Commonwealth Edison
 One First National Plaza, Chicago, Illinois
 Address Reply to: Post Office Box 767
 Chicago, Illinois 60690

August 18, 1975

**Subject: Dresden Station Unit 3
 Reload No. 3 Licensing Submittal
 Supplement E
 Control Rod Sequences
 NRC Docket No. 50-249**

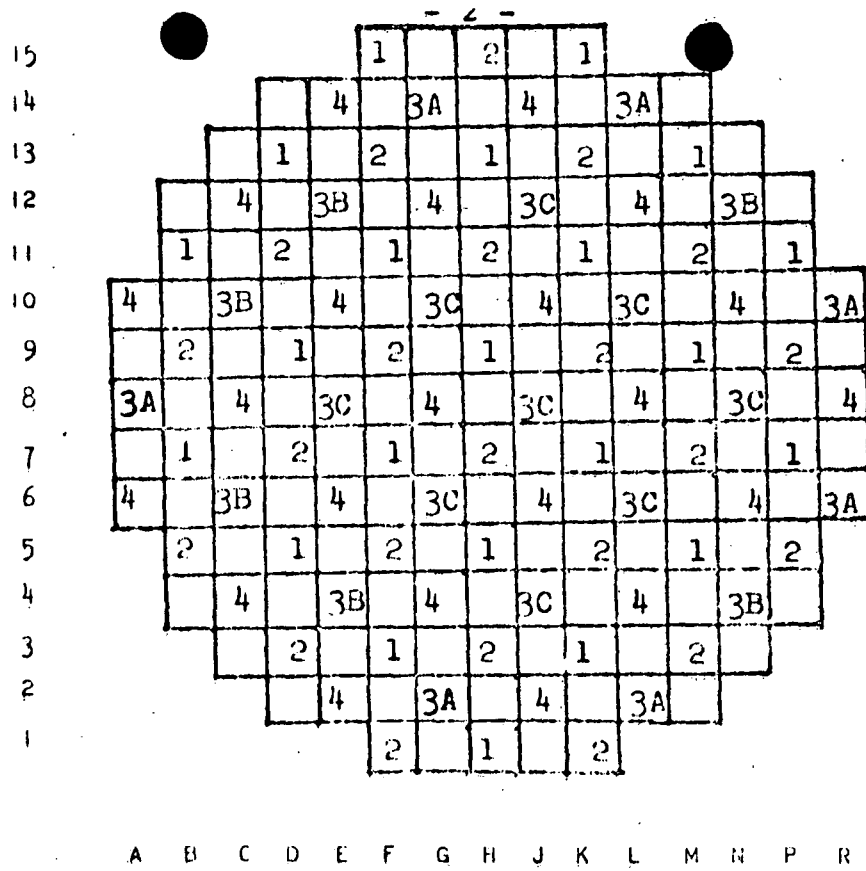
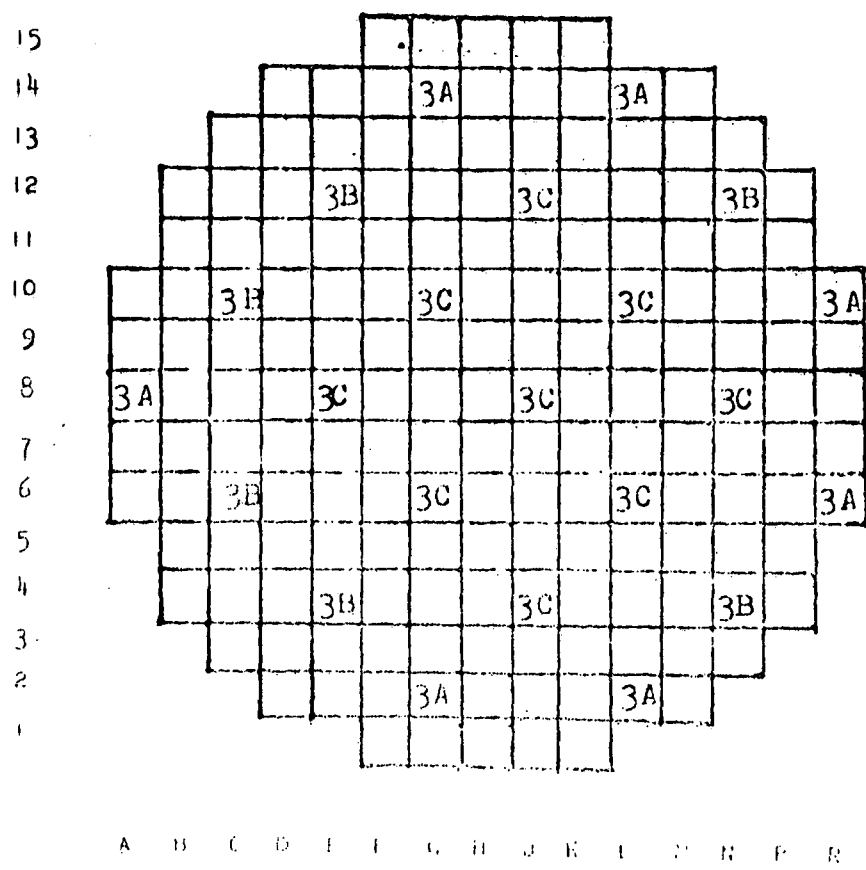
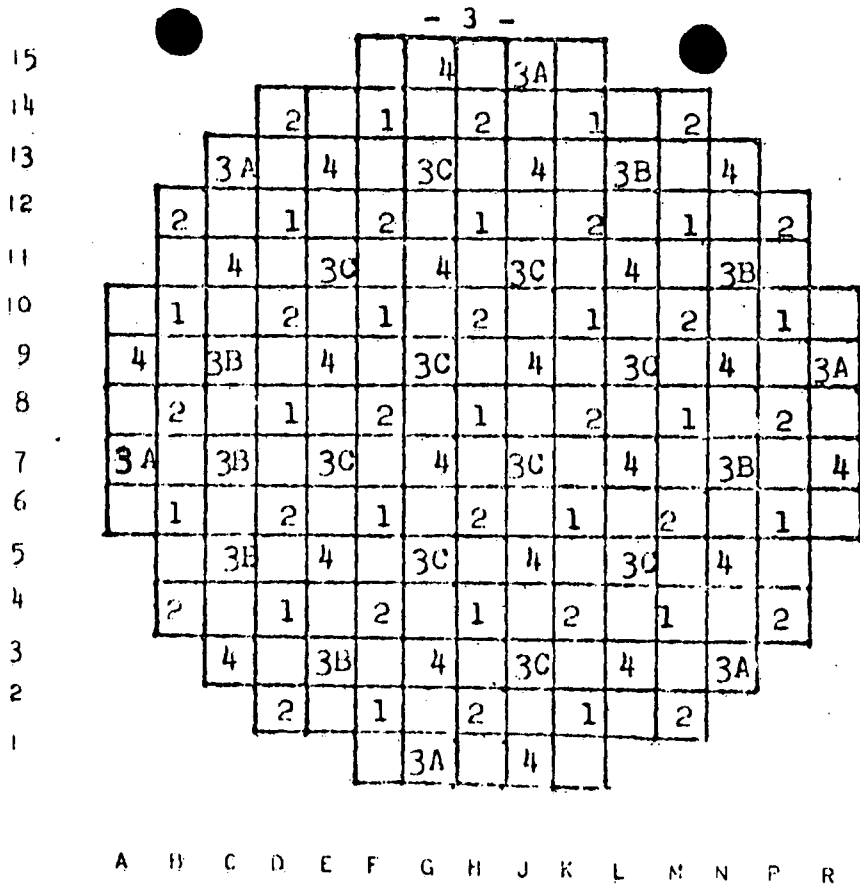
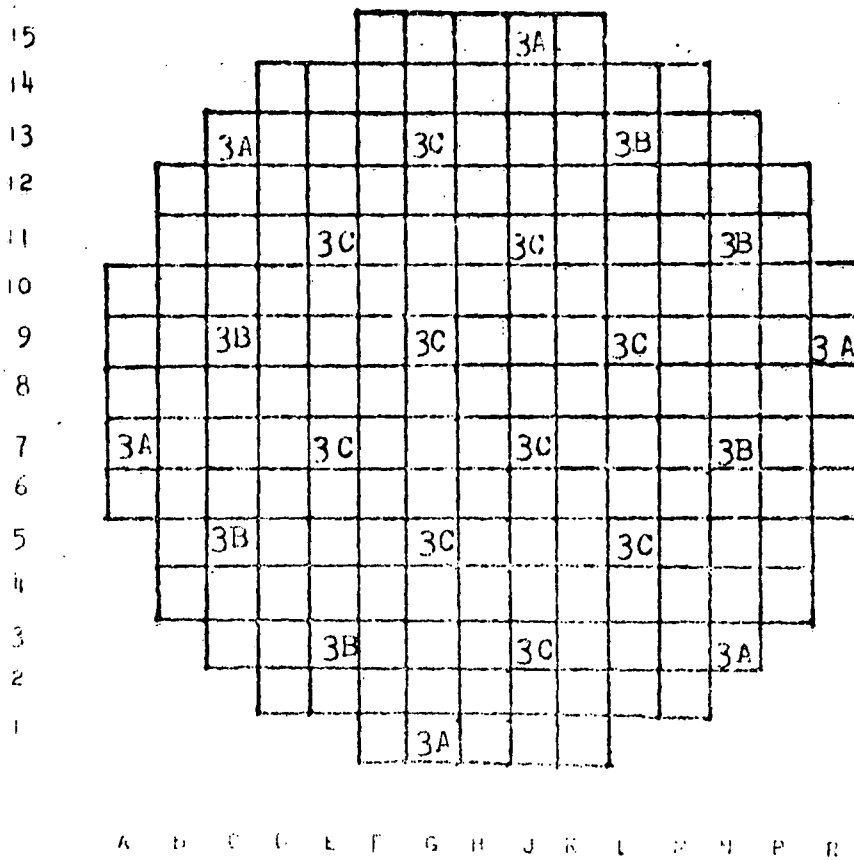
1. An "Accident Reactivity Shape Function" curve for the worst in-sequence rod using the CECO techniques. The curve will be developed consistent with Figure 6.3 of NEDO 20694, because the results must be within the GE envelope curve.

The General Electric control rod withdrawal sequence can be revised to avoid ganged withdrawal of rod groups 3 and 4 by splitting group 3 into three subgroups. This revised control rod withdrawal sequence is shown in Figures 1 to 5. Utilizing a FLARE type code, a steady-state accident reactivity shape function is presented in Figure 6 for the worst in-sequence control rod for groups 3 or 4 of either sequence. The rod worths were evaluated for Dresden 2 - BOC 4 at a hot standby, zero power, zero voids and xenon free condition. The worst in-sequence rod was a group 3 B rod (C-9) with groups 1, 2 and 3A of the B sequence fully withdrawn. The General Electric technical basis is included in Figure 6 for comparison.

Figure 7. Scram Reactivity Functions at 286 °C

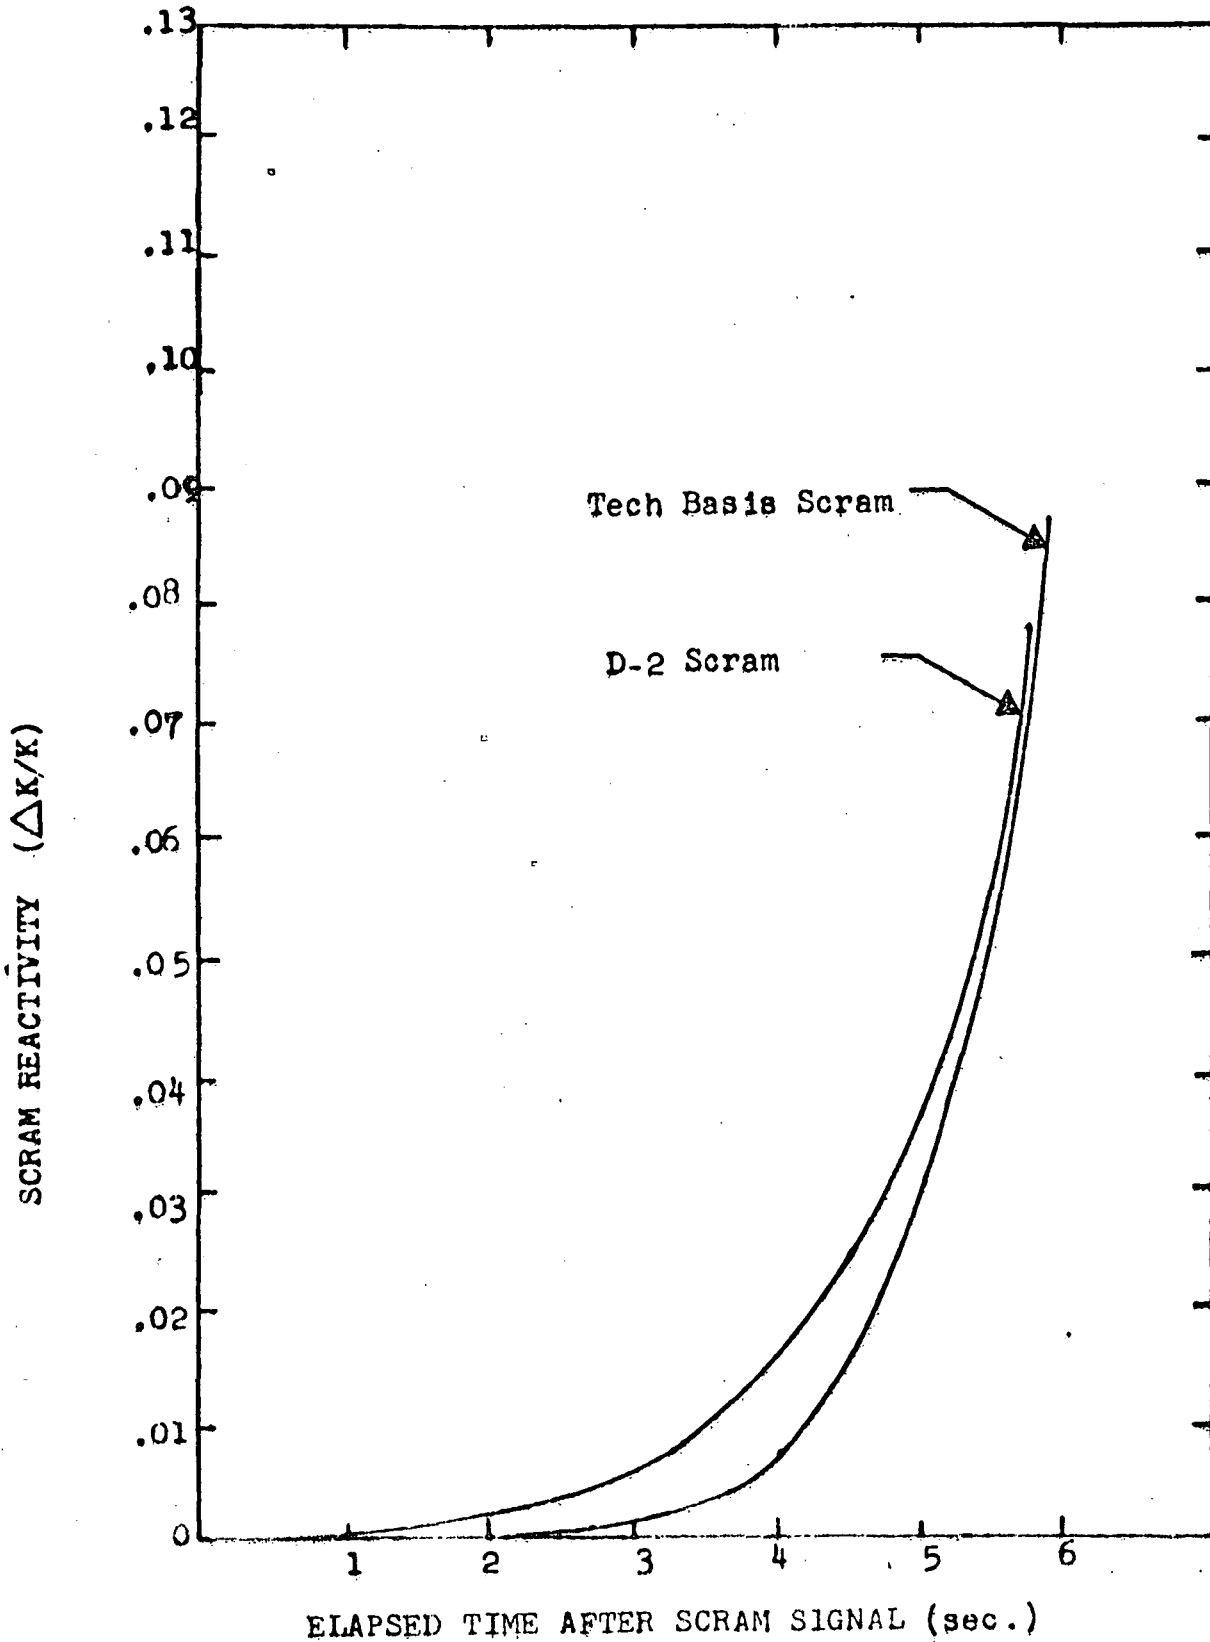
2. A "Scram Reactivity Function" for the rod drop accident. The function will be developed using CECO techniques but will be comparable to the envelope function of Figure 6-5 of NEDO 20694.

A steady state scram reactivity function is presented in Figure 7 assuming control rod C-9 remains in the fully withdrawn position. Design basis scram times are employed.

Linear interpolation was employed between insertion times with time zero equal to deenergization of the scram pilot valve solenoids. Final shutdown is achieved by scrambling all but the dropped rod under reactor conditions identical to those for Figure 6. The General Electric technical basis is included in Figure 7 for comparison.

Figure 8. Control Inventory vs. Exposure

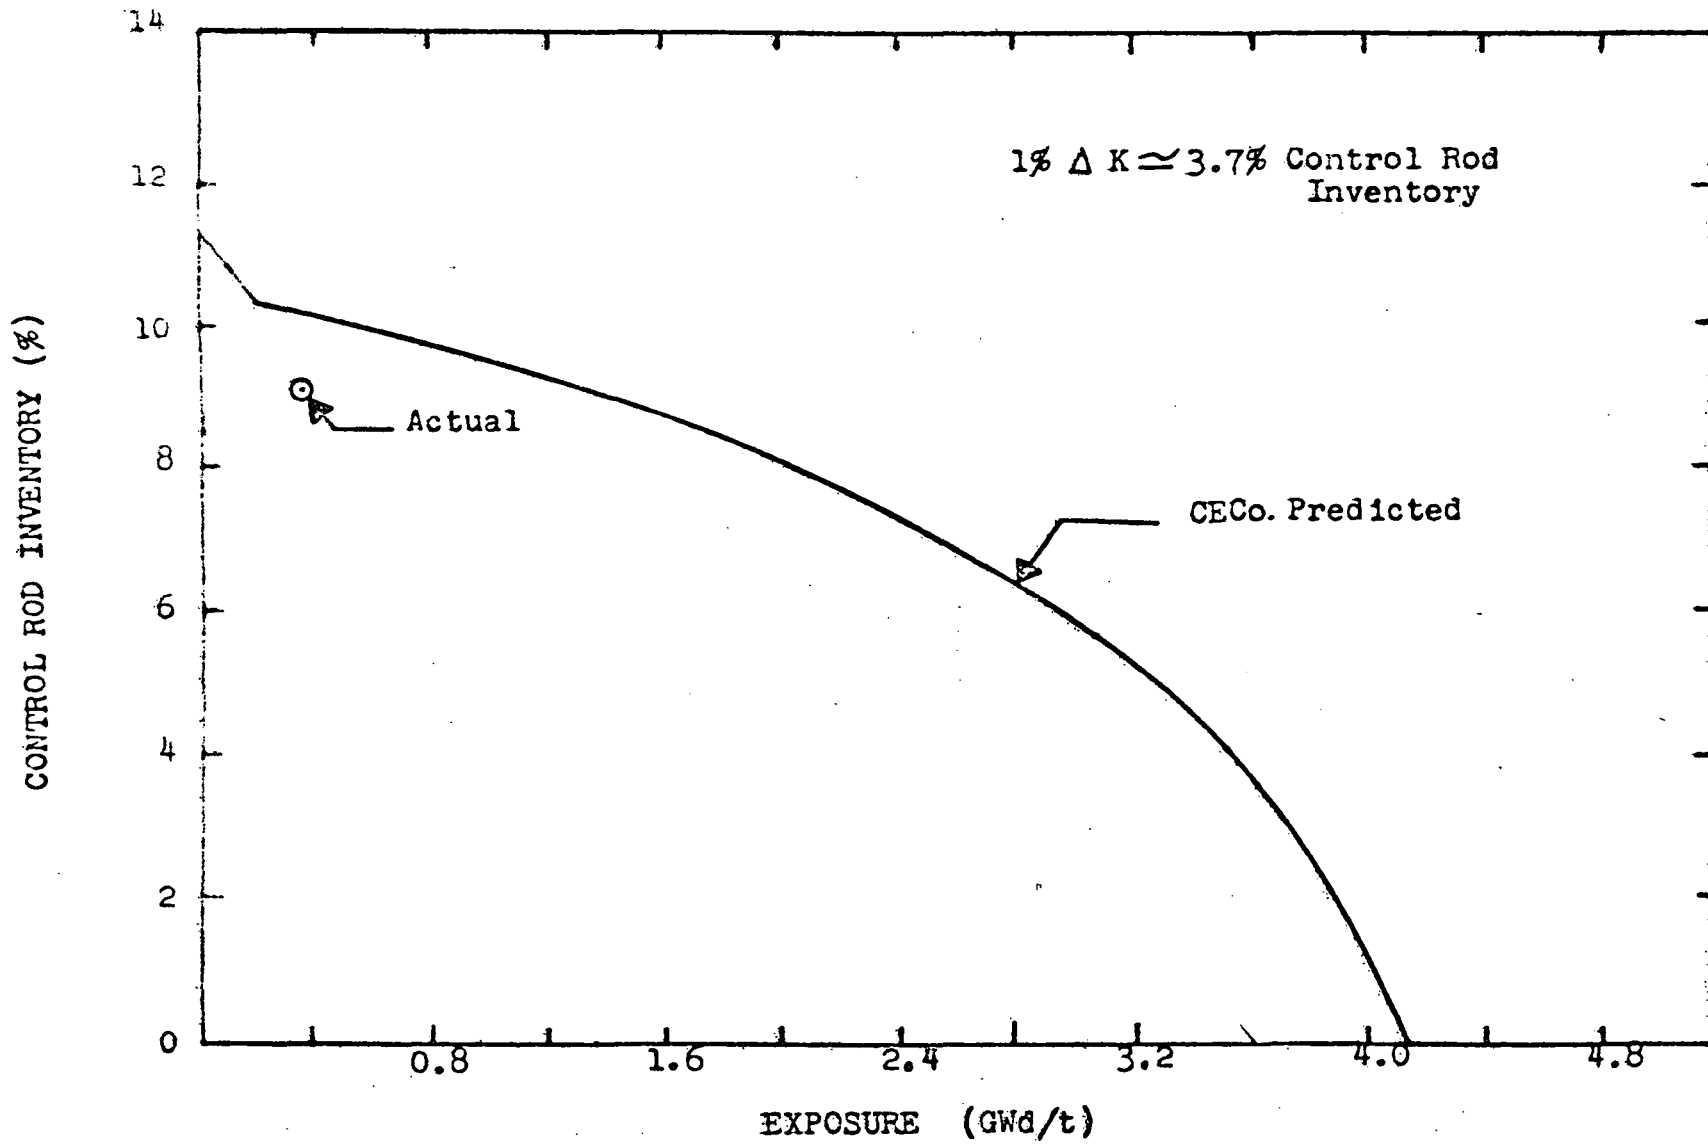
3. Justify (verify) the CECO. technique for developing rod withdrawal sequences which limit rod worth to less than 1.3% ΔK .

Commonwealth Edison Company has also predicted rod densities for Dresden 2, Cycle 4, which are presented in Figure 8. An actual data point is shown at an exposure of approximately 350 mwd/t into the cycle.
